Item ID: D4298-001**Revision ID:** PREI IM**Item Name:** Chart Holder Assembly**Start Date:** 11/25/2010 **Start Qty:** 1.00**Accept****Setup****Start****Required Date:** 12/3/2010 **Req'd Qty:** 1.00**Cust Item ID:****Customer:****Reference:****Approvals:** Process Plan: MDate: 10/11/26

SINGLE PILOT VFR
CHART HOLDER, AW139

DWG. NO.
13939-1-290
SHT 2 OF 10

From: Domingue, Elvin [edomingue@erahelicopters.com]
Sent: December 17, 2010 10:24 AM
To: Nelson, David; 'echarbonneau@dartaero.com'
Subject: Re: washer addition

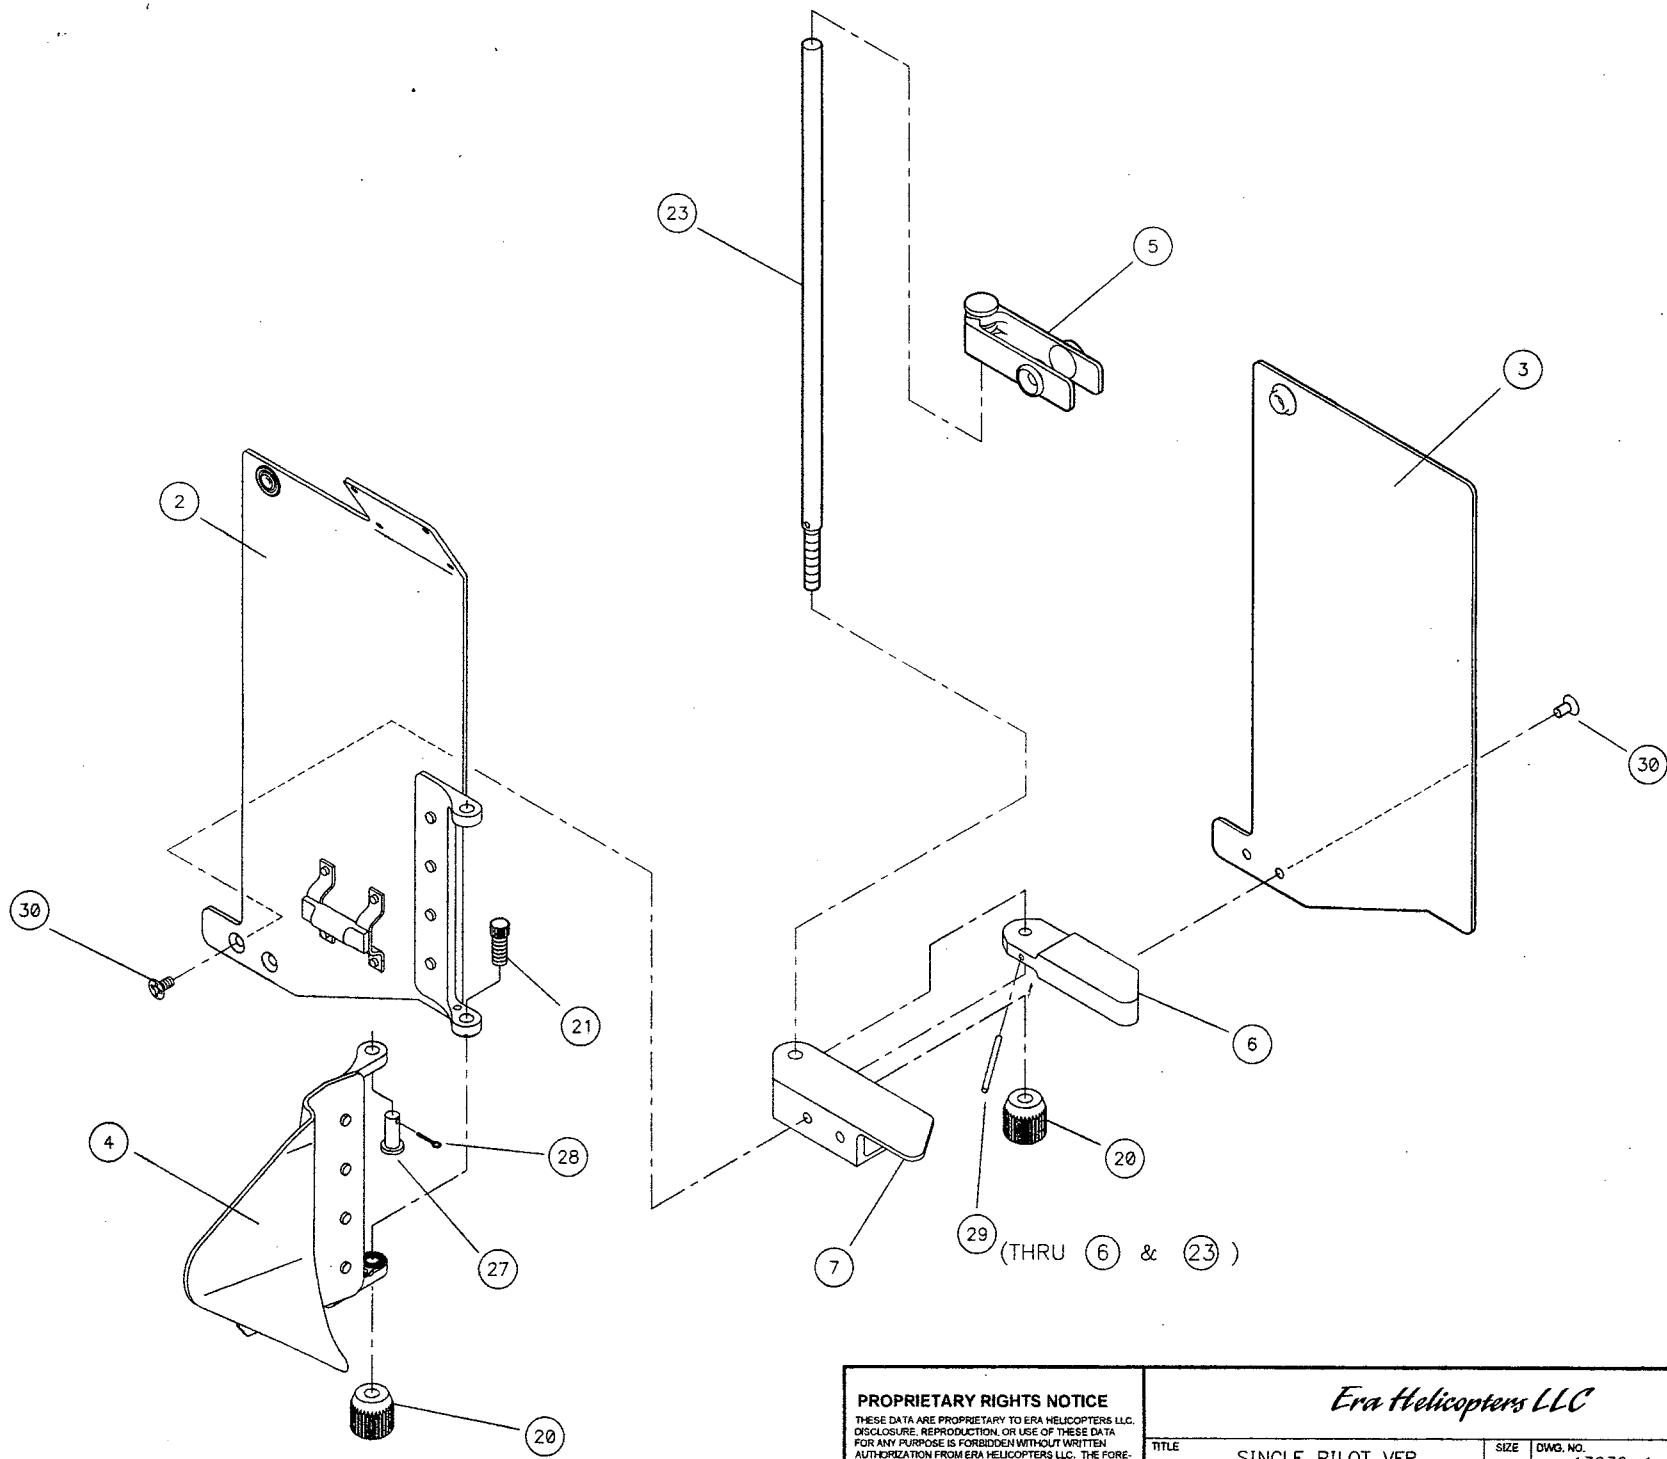
Good morning David, for better function we added one AN960JD416 under both knob (see attached mark-up) please let me know if this is ok with and also I noticed on p9. of the drawing there's a typo on the depth of the threaded hole for the knob... should be 0.60" deep not 0.06". I Also attached a picture of the completed ass'y... looks pretty good.

That looks good. The added washer seems fine. The only other thing I would add is that all exposed hardware and surfaces would be painted.

I'll update and re-send the drawing with the knob depth fix, and add the other changes once approved.
